FIRE SAFETY INSPECTION REPORT

ARTISTIC DESIGN LIMITED
232-233 NARASHINGHPUR, ASHULIA, SAVAR

ACCORD
on Fire and Building Safety in Bangladesh

March 25, 2014

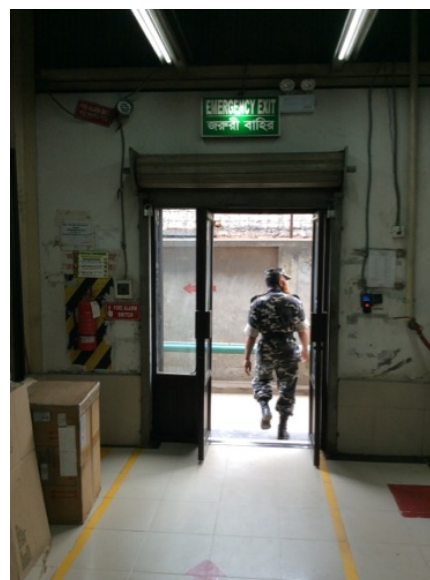
F-8	Egress	Storage was located in the exit stair.	Remove all storage from exit stairs and egress paths.	Immediate
-----	--------	--	---	-----------

Locations:
All exit stairs.
